ATR on Quality Control Check Report. (Apartments)

Quality Control Check Report

**GULMOHAR RESIDENCY**

Details of Additions & Alterations

Changes in kitchen platform: (mark on plan)

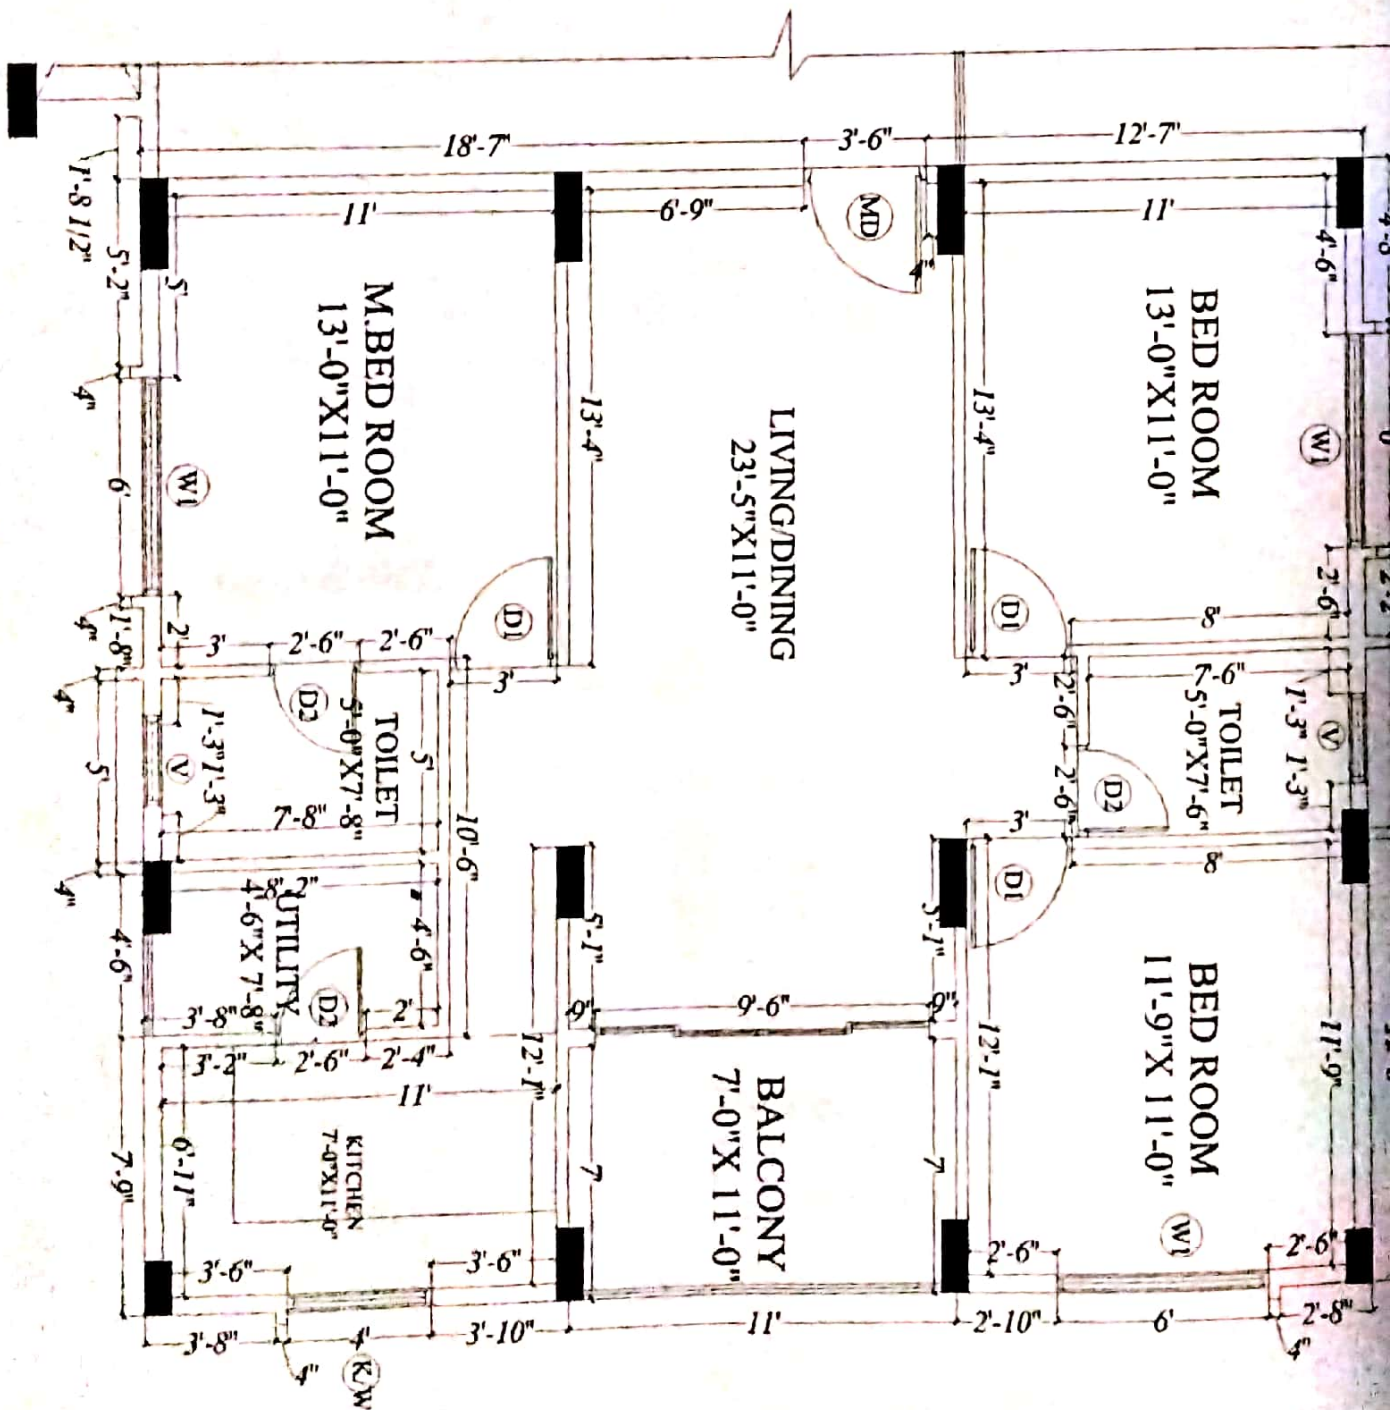
→ Kitchen plastic paper.

→ well & healthy like - Turkey chocolate.

WORKING PLAN-1360 SH-A2 TYPE

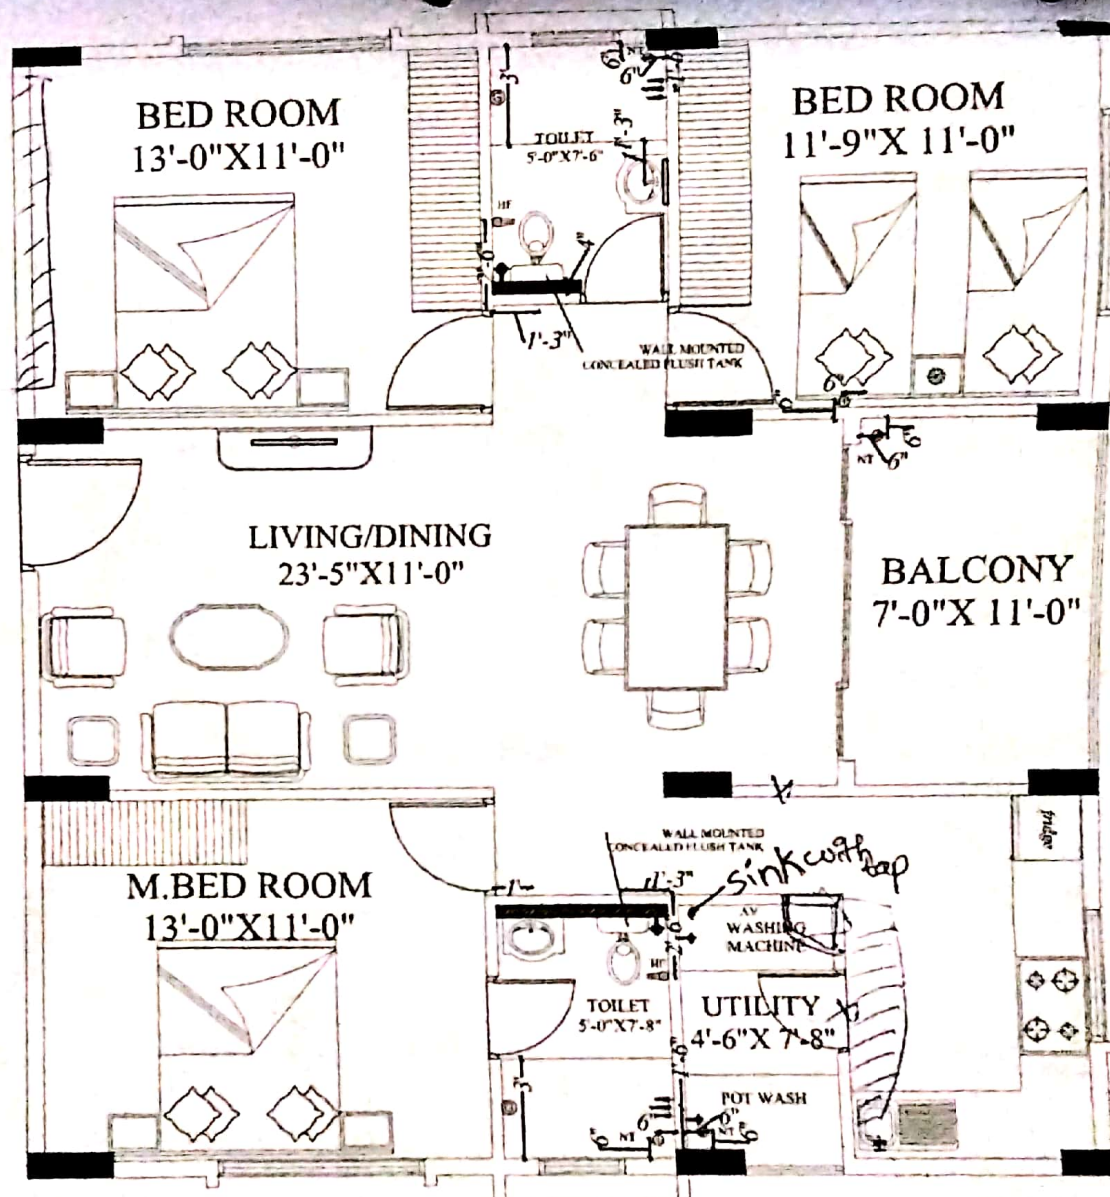
AS per customer's Request Couple of electrical and plumbing points were changed. Switch Board's were missing in K-Bed and Gr Bed. Couple of
